REQUEST

Current Zoning: R-3 (single family residential)
Proposed Zoning: UR-2(CD) (multi-family residential, conditional)

SUMMARY OF PETITION

The petition proposes to allow a multi-family residential development on a vacant parcel of land in southwest Charlotte, northeast of Rivergate.

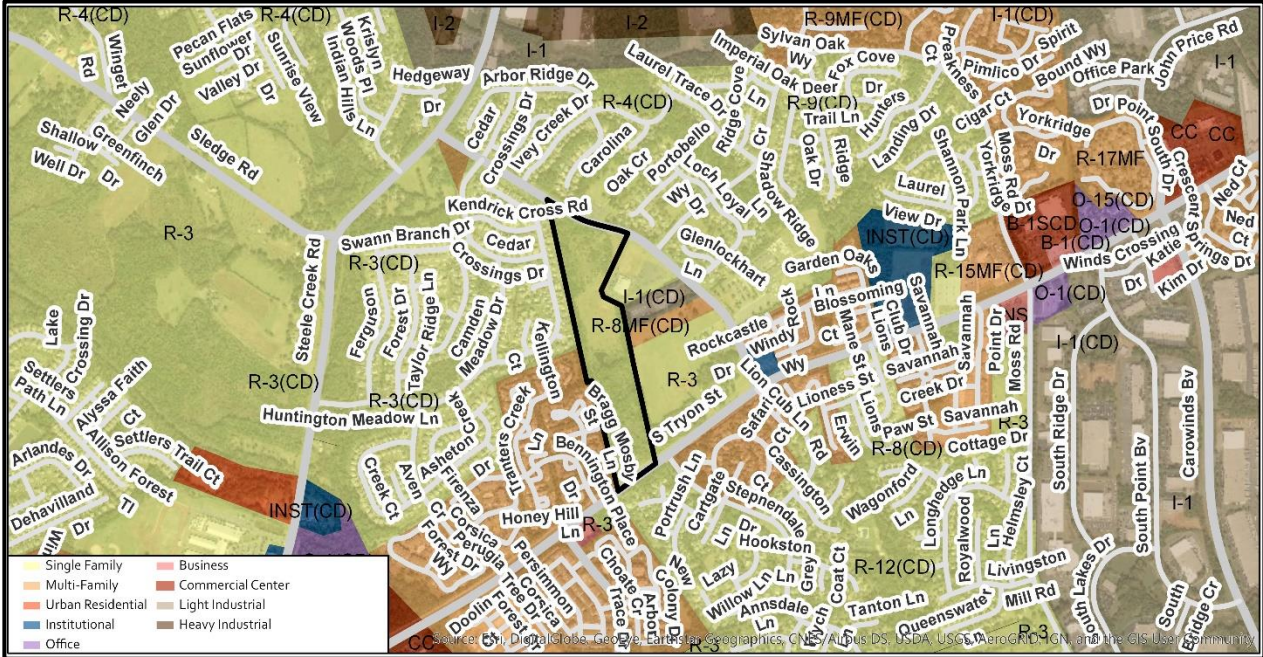
1. Reduce density of proposal to better conform to the recommendations of the area plan.
2. Consider reducing building masses of buildings 6, 7, & 8 to better transition to adjacent single family uses.
3. Increase fence height from 5 feet to 6 feet along adjacent single family property lines, and clarify fence type to ensure it provides adequate screening.

4. Under Site Data remove "Min. Building Separation: 10' Per Ordinance" from the site plan.
5. Label setbacks along Erwin Road and Public Road A.
6. Confirm if the area adjacent to proposed Building 3 is a dumpster enclosure/refuse area. If so, label on the site plan.
7. Remove Monument Sign label and proposed location from the site plan.
8. Petitioner proposes a 50-foot Class C buffer along the western property line. Open Space and Amenities Note VII.3 proposes a "minimum 37.5-foot Class C buffer" in this location. Petitioner should clarify intent to have ability to reduce buffer by 25% with wall or fence per ordinance and modify labelling and development note to reflect consistency.
